ADDENDUM NO. 1

OAKDALE PARK LANDSCAPING IMPROVEMENTS

Dated: January 13, 2010

PAGE 1: 3 Concrete Planter Installation

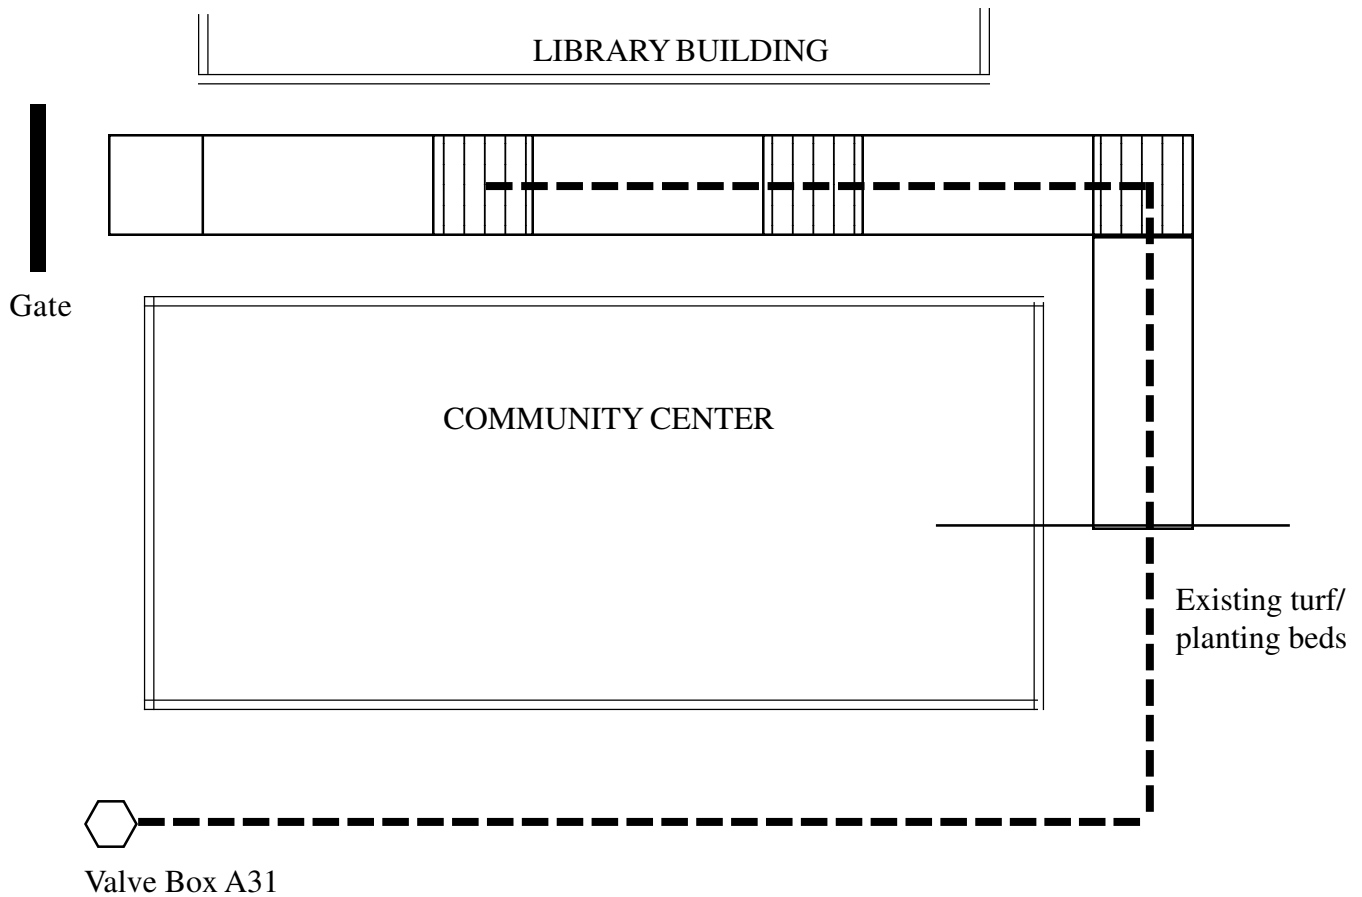
- A. Run Sch.40 irrigation line from Valve Box A31 to the east and around the community center to the concrete and under the concrete connecting the three planters. Use the same valve box to connect to keystone planters and the Gymnasium planter.
- B. Remove the center concrete pads for the irrigation lines. Replace concrete as the same finish.

PAGE 2: Gymnasium Planting Bed Addition

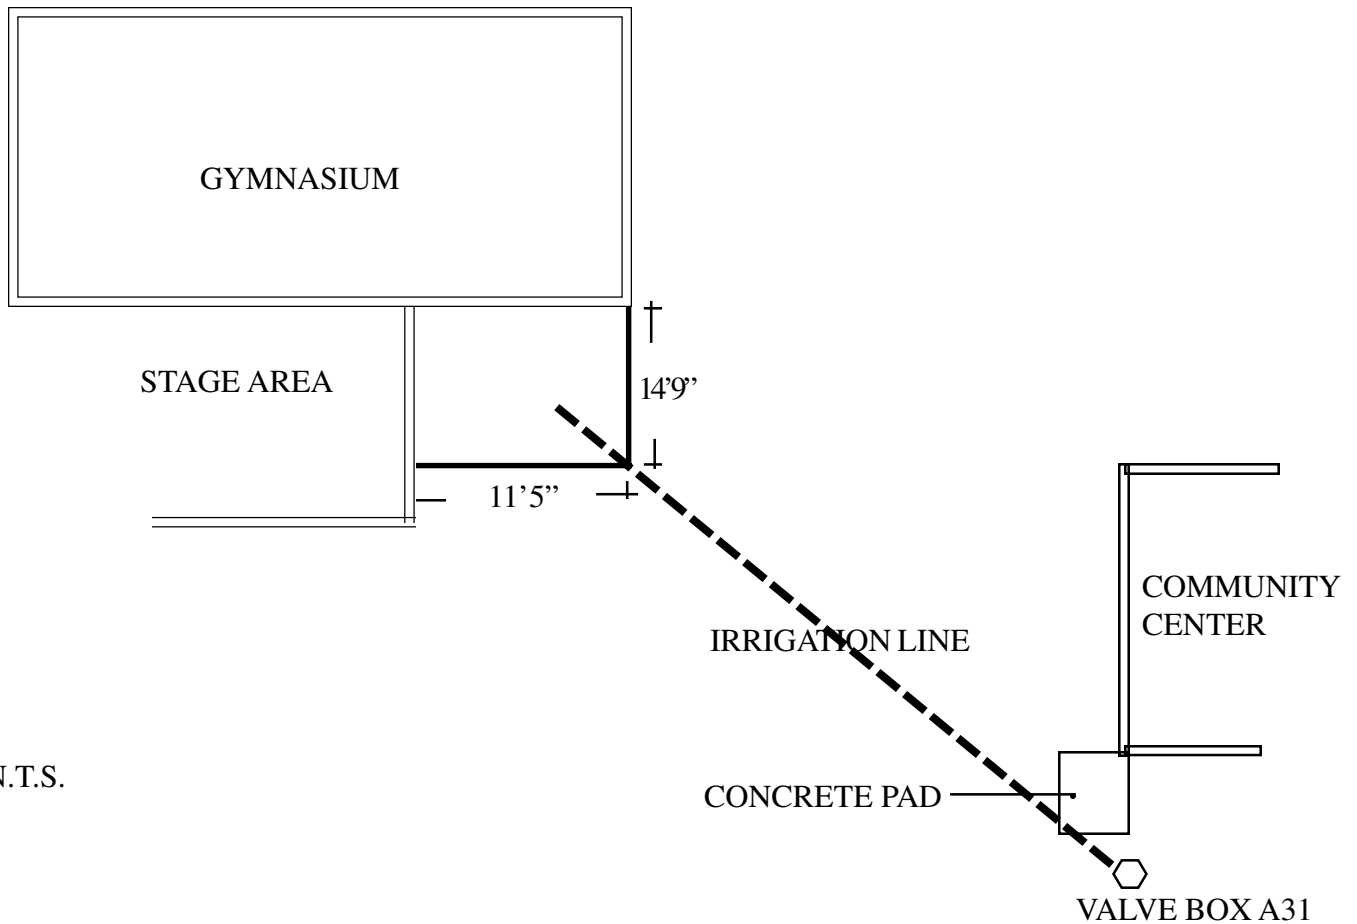
- C. Add 5'x5' concrete pad connectng the concrete walkway at the southwest edge of the community center to the existing concrete pad on the west side of the building.

- A. The dimensions for the bed are 11'5" x 14'9". This includes removing four sections of concrete and cobble.
- B. Trench from valve #A31 located approximately 8 feet south of the community center building on the east side.
